## ASSESSMENT REPORT APPENDICESÁ

**DRAFT CONDITIONS OF DEVELOPMENT CONSENT**  
**Development Application No. DANo9**

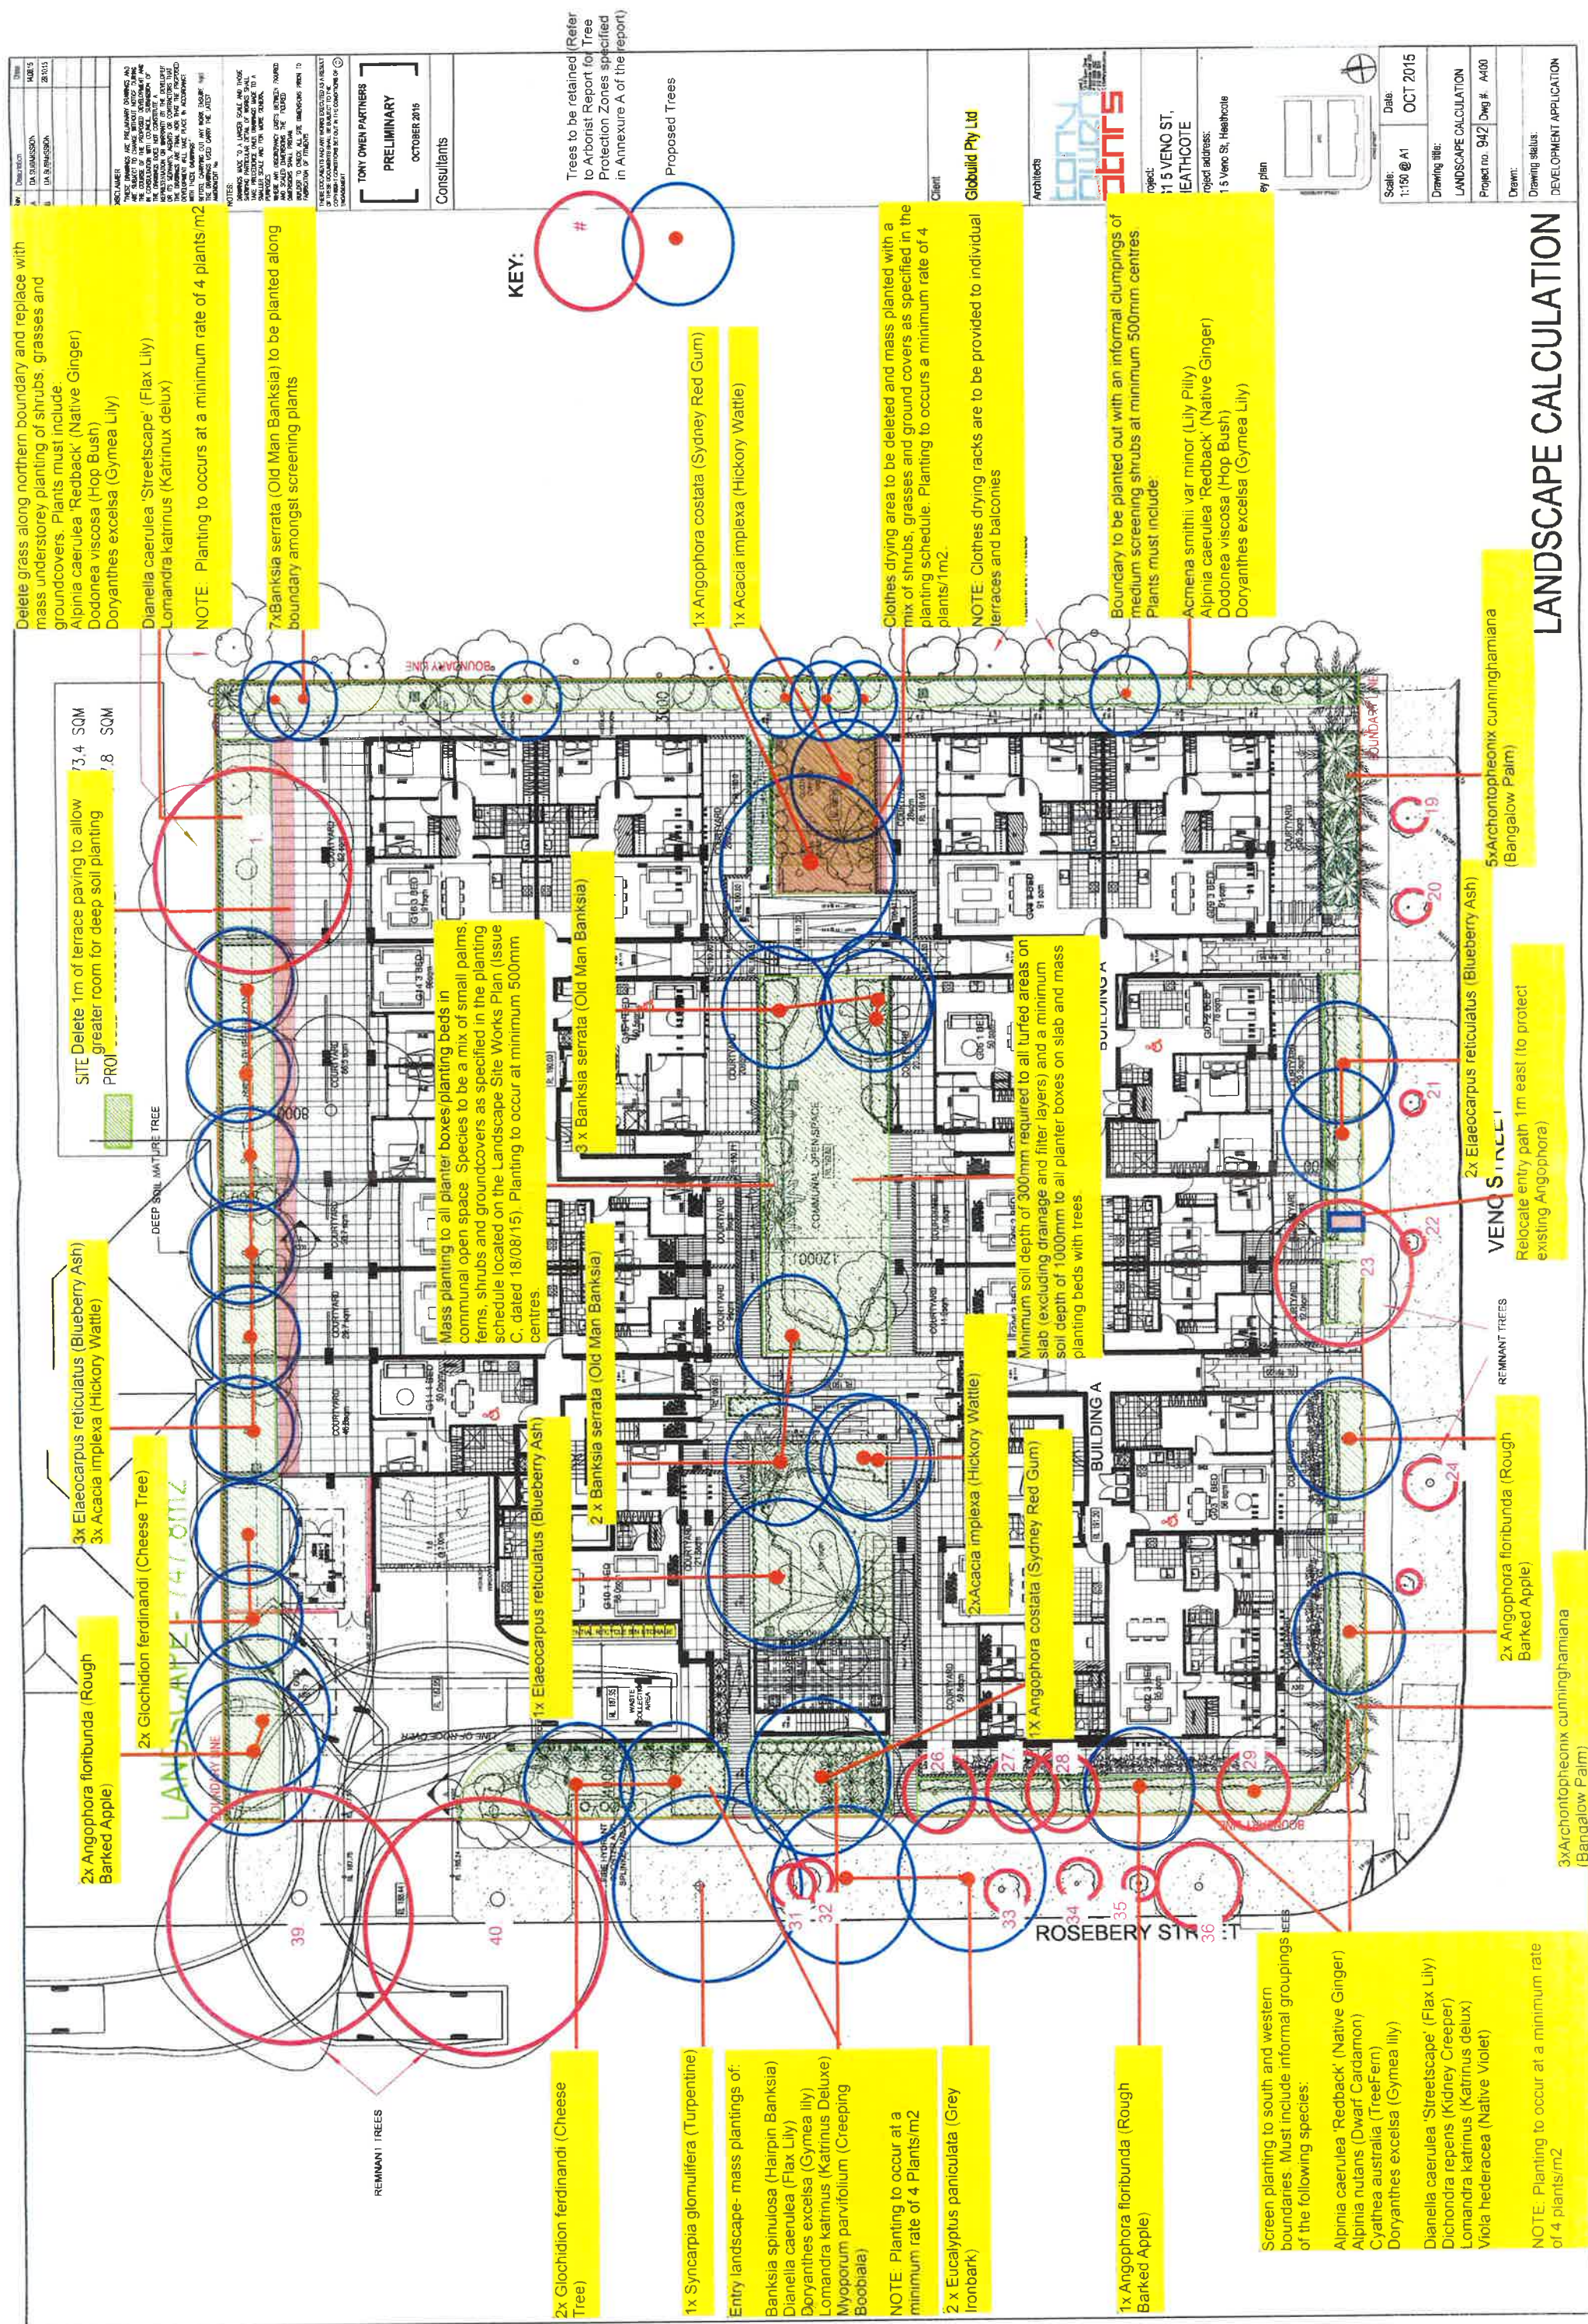
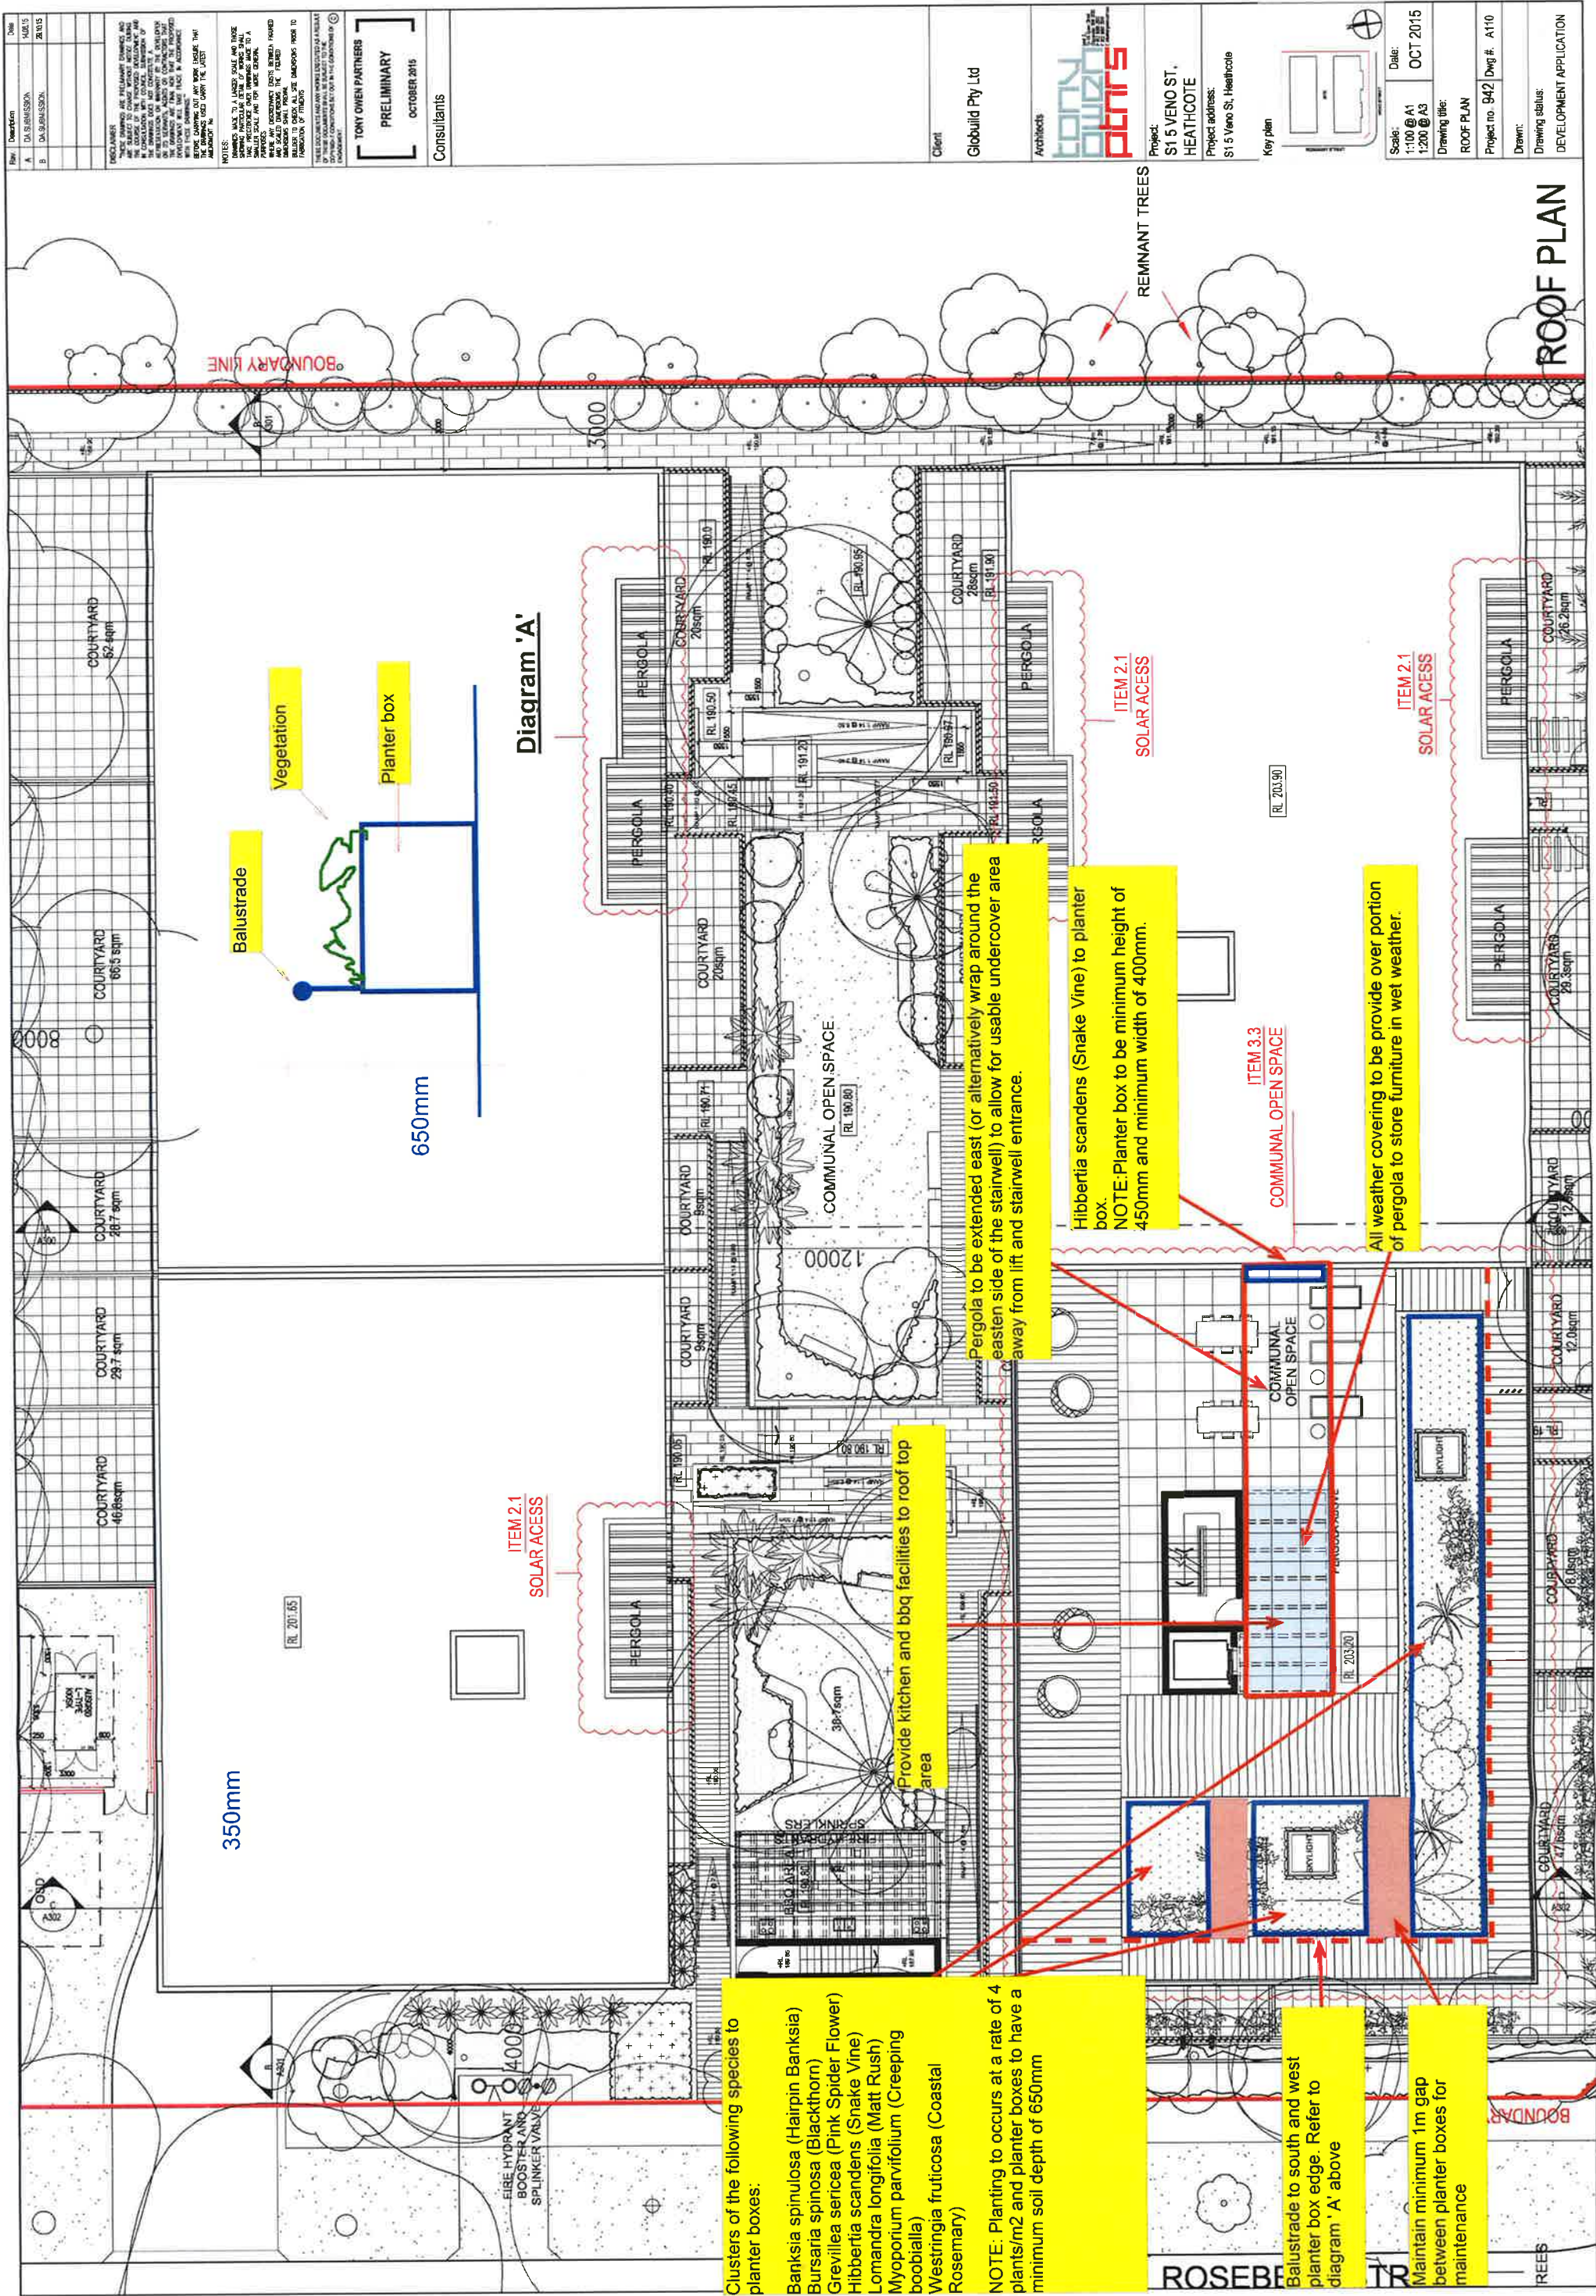
This proposal has the potential to be a quality precedent for denser developments in a suburban context. However, the ADG non-compliances to both internal and external spaces indicate that the proposal may be slightly too big for the site.

The applicant needs to co-ordinate the Sketch-up model with the other drawings, and to clearly show the landscaping in this model, to allow proper assessment.

The proposal also needs to demonstrate how the significant change of scale along Rosebery Street will be handled, incorporating appropriate landscape and to strengthen the quality of the central space, not just meet numerical compliance.”
